DEPARTMENT OF DEVELOPMENT SERVICES – PLANNING DIVISION

REPORT: 123 Beacon Street, Hartford, CT 06105

STAFF REPORT

PROJECT: 123 Beacon Street
PARCEL ID: 112-366-036
ENERGOV ID: COMM-2021-0312

Figure 3: Site Plan of Proposed Addition

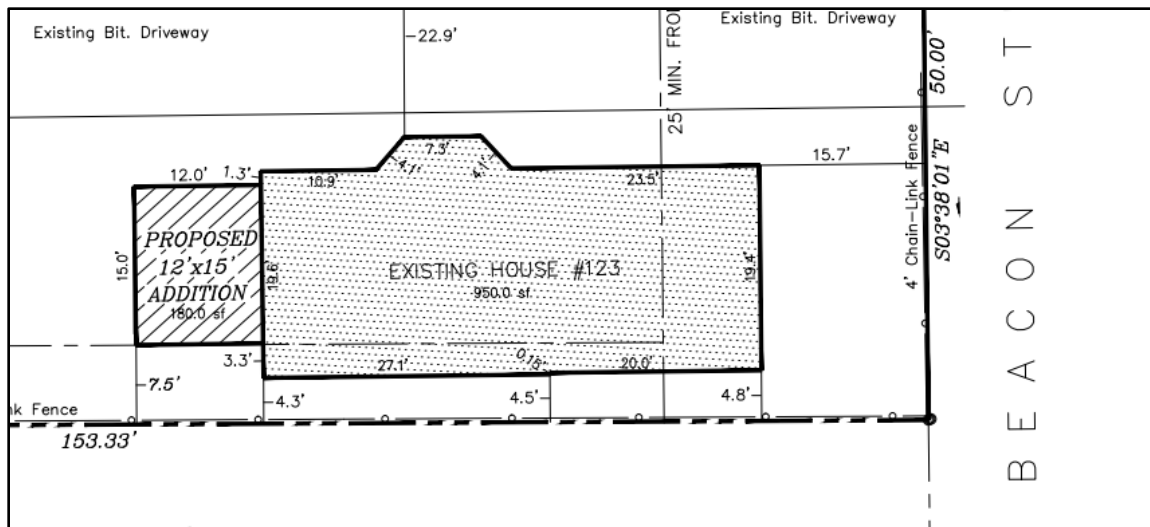
The proposed addition would be to the structure's rear façade. The proposed addition would be visible from Beacon Street, so Commission review is required. The addition would be partly obstructed by the existing structure and relatively distant from the street. The existing structure has a depth of 47.1' and the proposed addition would extend an additional 12'. The addition would be relatively small compared to the massing of the existing structure.

The proposed dimensions suggest that the windows may be a different size as well. It is difficult to say how it might affect the appearance because, as of this writing, the applicant had not provided elevations of the proposed side façade. Since the applicant still needs approval for their site plan, staff has included a condition of approval that would require submitting elevations and details prior to the submittal or approval of the site plan review.

1. The Applicant should install 1/1 metal windows with components whose dimensions and profile match the rail, stiles, and area of glass of the existing windows as closely as possible.
2. The windows should have wood trim that matches the dimensions of the trim used for the existing windows.
3. Prior to the submittal or approval of a site plan application, the applicant shall provide elevations and product details deemed by Staff to be sufficient.

Figure 5: Missing Siding 123 Beacon Street, Staff Photo, January 10, 2021

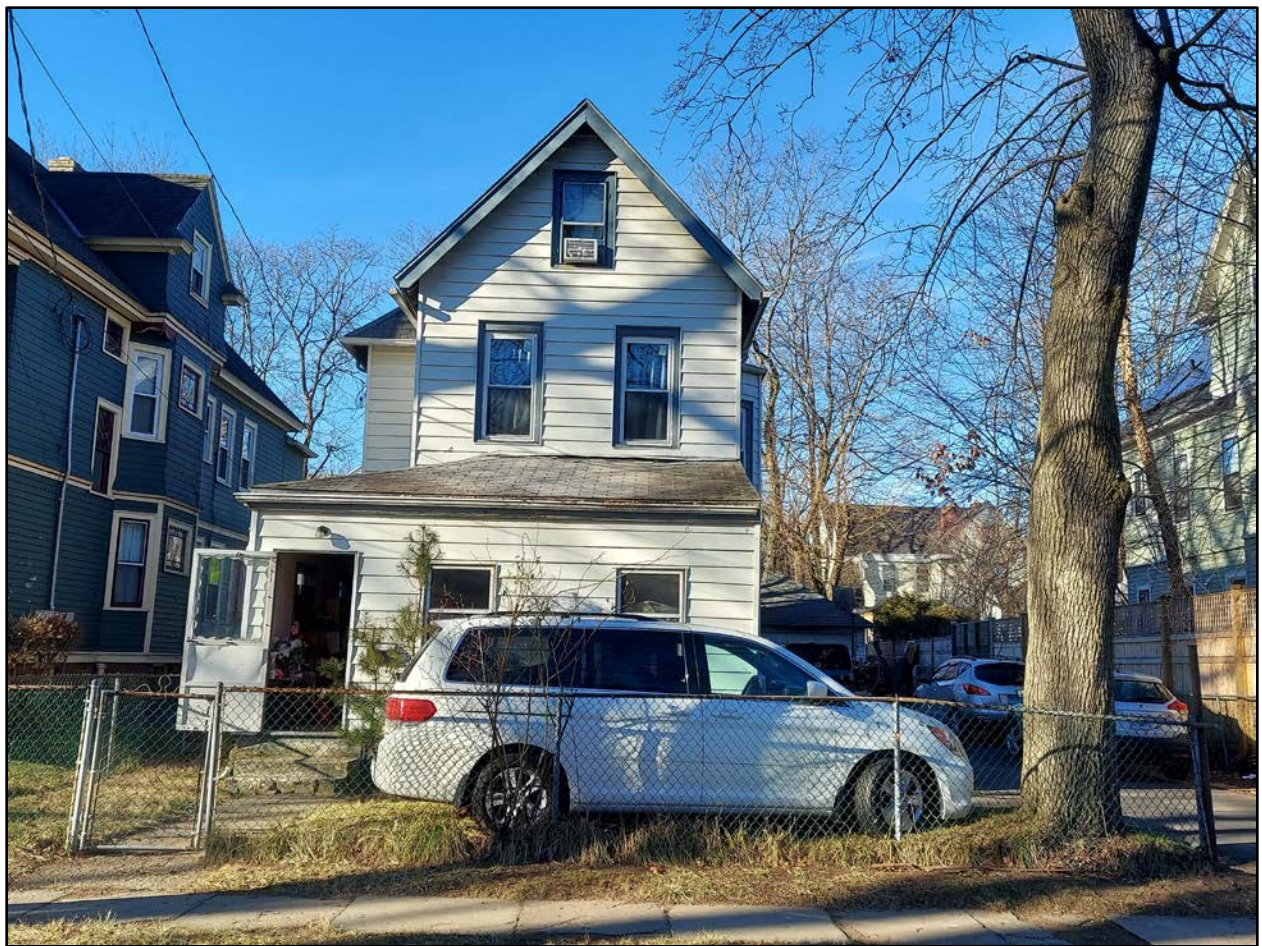
Current Conditions: The structure is significantly altered with an addition to the front and side façades. Asphalt shingles are installed on the existing roof. The existing structure has 1/1 metal windows with wood trim. A section of siding on the right or southern façade of the house has been removed, which Staff noticed during a January 10 site visit. Staff informed the city's zoning enforcement officers about the removal.
